March 15, 2006

RE: Smith Ranch-Highland Uranium Project
NRC License SUA-1548, Docket No. 40-8964
License Amendment Request- Reynolds Ranch Amendment Area, Responses to
NRC Requests for Additional Information

**POWER RESOURCES, INC.
REYNOLDS RANCH AMENDMENT
LICENSE SUA-1548
SMITH RANCH-HIGHLAND URANIUM PROJECT
RESPONSES TO NRC REQUEST FOR ADDITIONAL INFORMATION**

FIGURE 2-3

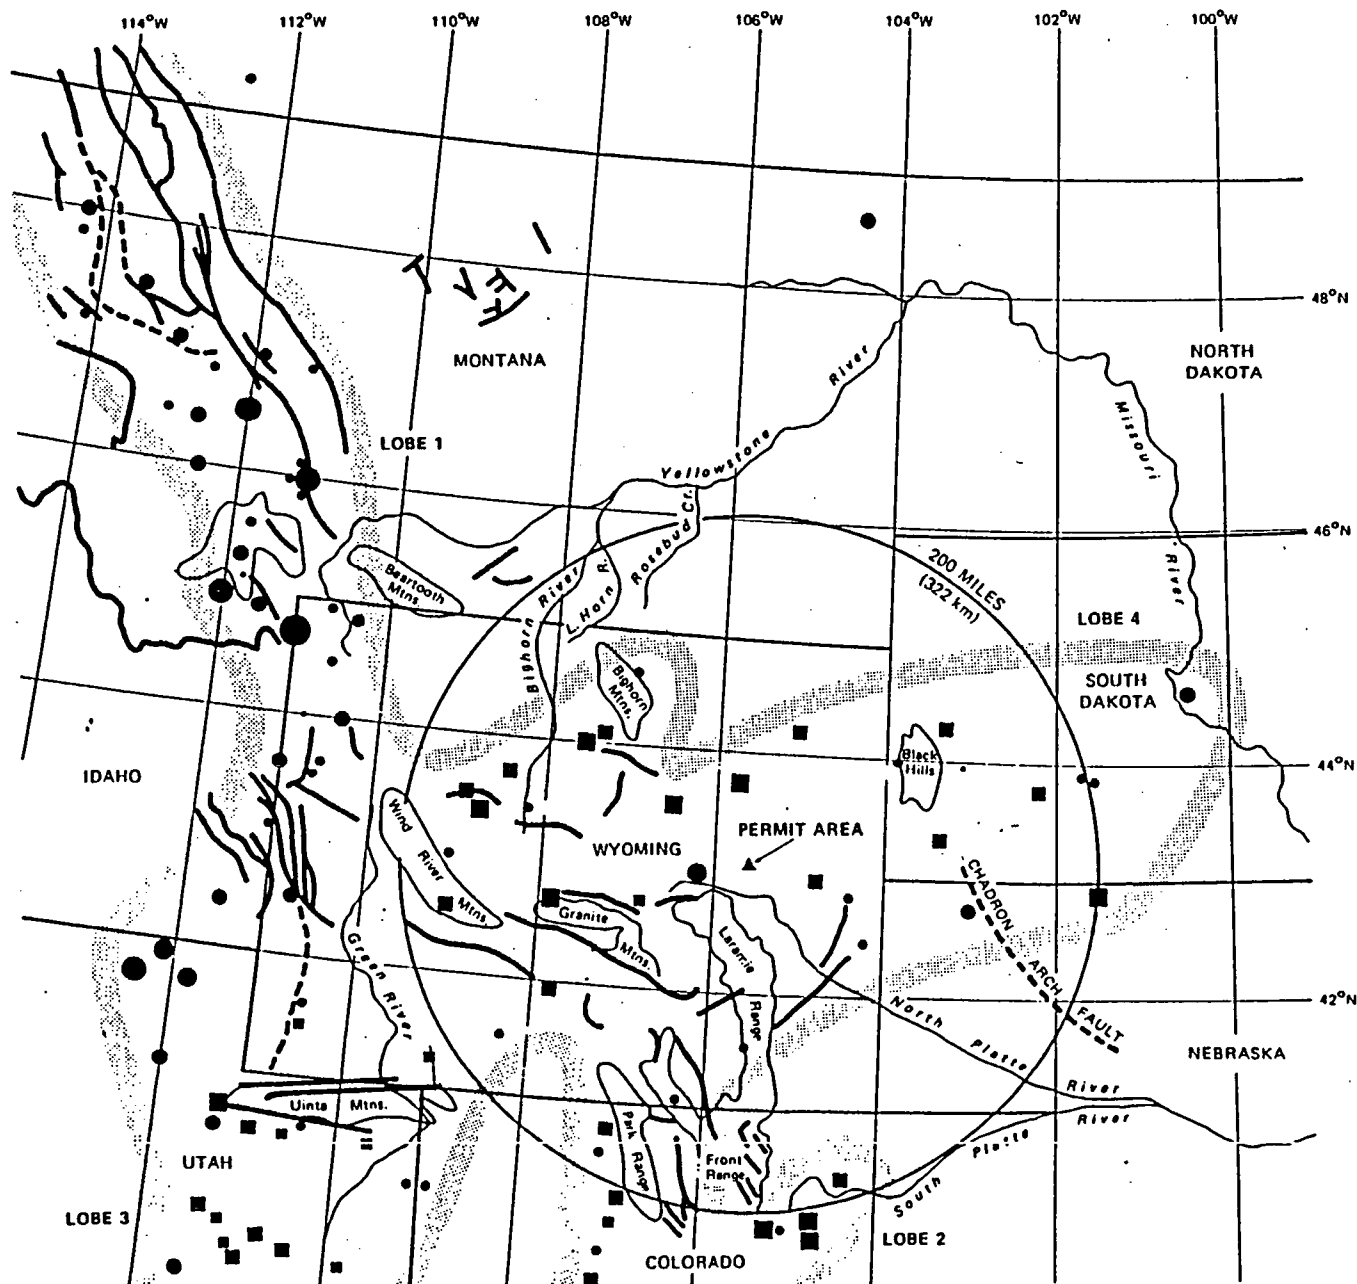
NRC Comment No. 8. Wind Rose data presented in Figure 2-3 is over 34 years old. Please substantiate that these data are consistent with recent wind direction and speed trends.

A new Figure 2-3, wind rose for Casper/Natrona County International Airport, has been included in Chapter 2 of Volume I that covers the period of 1961 through 1990. The wind rose was obtained from the Wyoming Climate Atlas and the data is consistent with the previous wind rose.

FIGURE 3-11

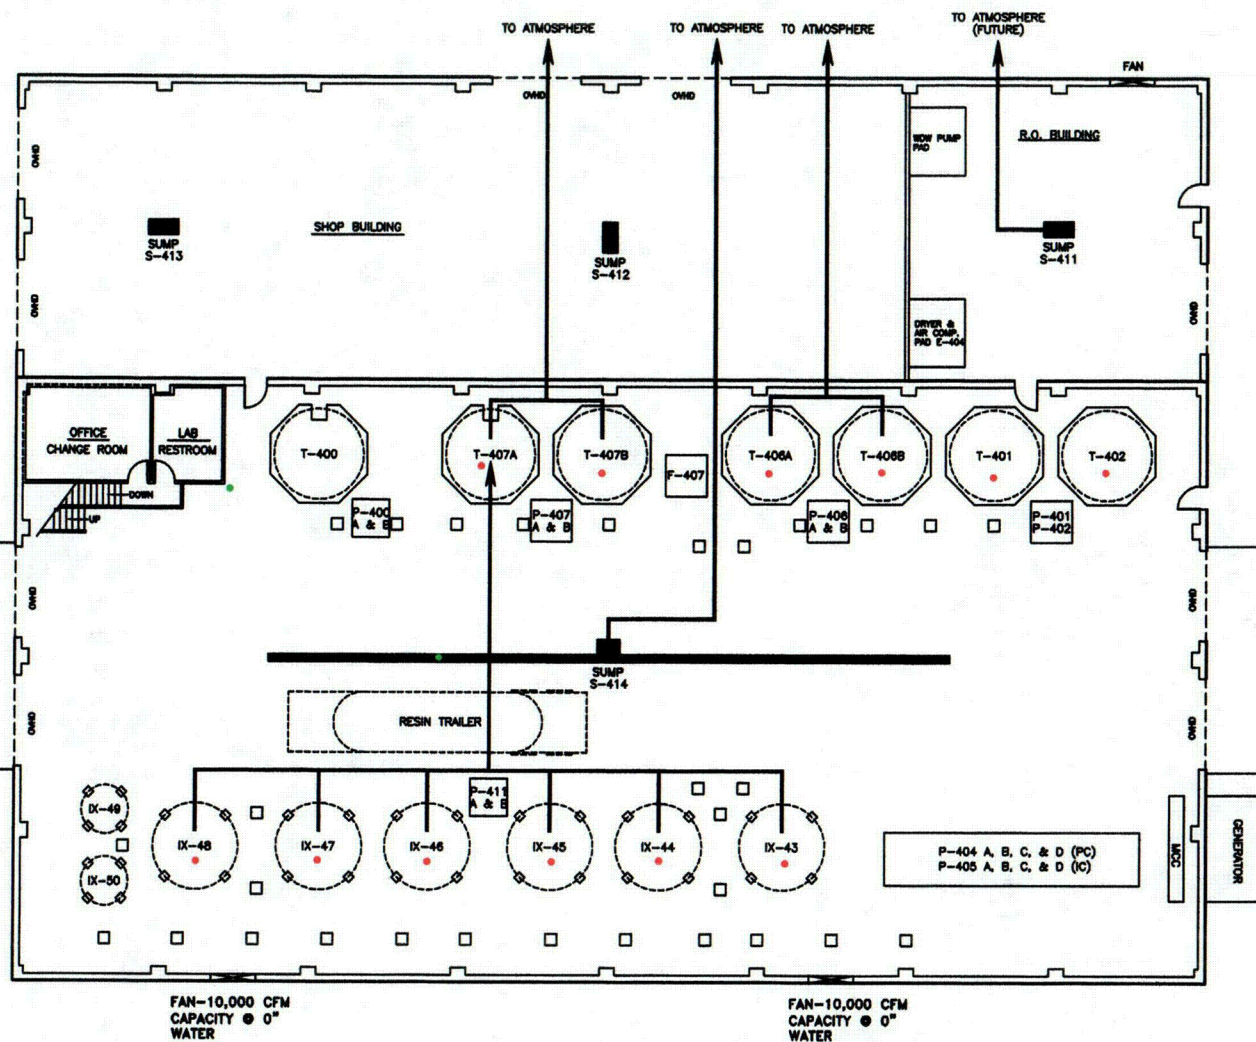
NRC Comment No. 13. Please provide a more detailed discussion concerning the

ventilation system discussed in Section 4.1.1 and the system shown in Figure 3.11. This discussion should include the size and function of venting from the IX tanks, sump, waste disposal well tanks, and resin transfer tanks.

The venting system from all tanks and sumps consists of 4 to 6-inch PVC piping and function to vent radon gas to the outside atmosphere (see Figures 3-6 through 3-12 for schematic of ventilation systems for CPP and Satellites). Where needed, exhaust fans can pull the air from the top of the tanks or from a sump and discharge the air with any gases and fumes to a vent placed on the outside of the building near the roof level. Section 4.1.1 was revised to show this information and included in the revised Chapter 4 of this submittal.

Figure 3-13
Smith Ranch-Highland Uranium Project - Estimated Time Table of Mining Related Activities

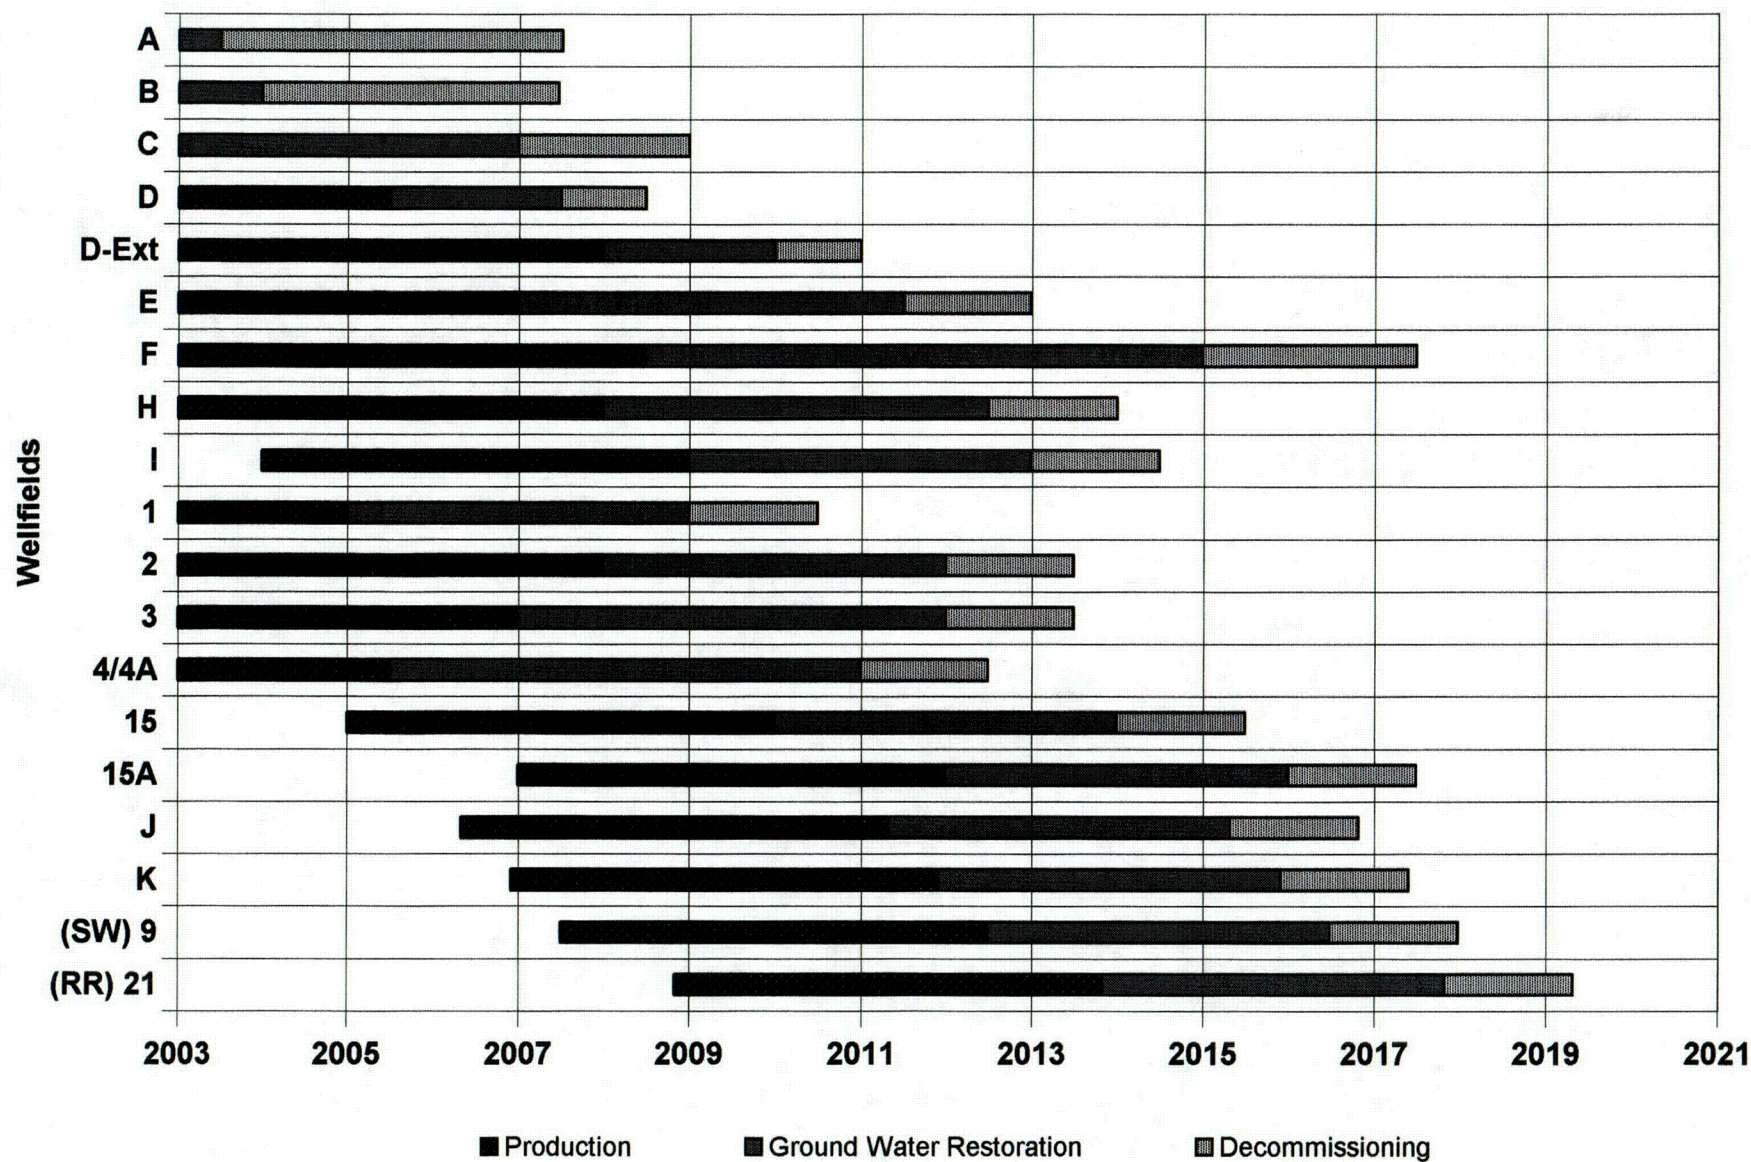
- 3) Figure 3-13, "Estimated Time Table of Mining Related Activities" was updated to reflect the startup of operations in the southwest portion of the License Area (Mine Unit-9).
